IREDELL COUNTY HEALTH DEPARTMENT

IMPROVEMENT PERMIT / AUTHORIZATION TO CONSTRUCT / OPERATION PERMIT / EXISTING SYSTEM

✓ SUBDIVISION: The Point on Norman SECTION: 1A LOT # 69 LOT AREA: 1.112 AC DESIGN FLOW: 480 L.T.A.R.: .275

AS BUILT SKETCH

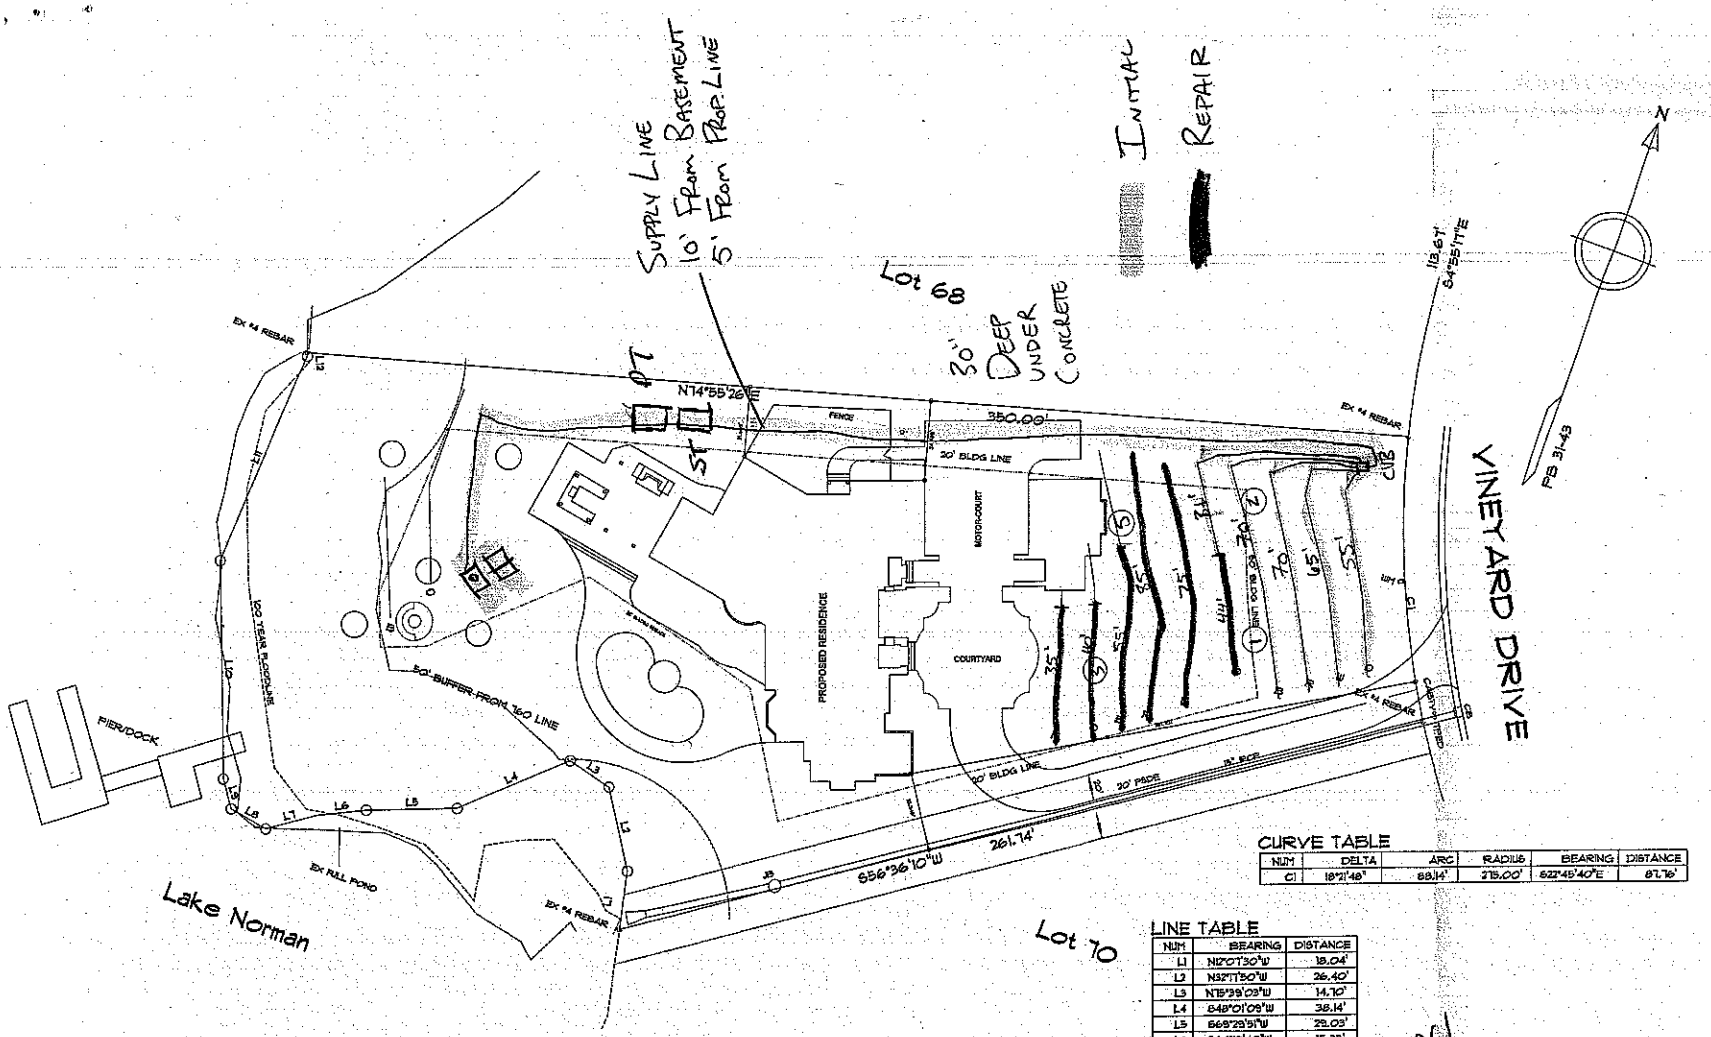
3/1/16 Checked tanks. Tanks moved to side of house, meets all setbacks
3/7/16 Checked lines, installed - MD
Essentially as drawn.

5/19/16 Set pressure, Checked leak & alarm

Location of the proposed Inground pool addition does not appear to impact the existing on-site septic system or well. **NOTE: Must keep pool cut at least 15ft from Septic
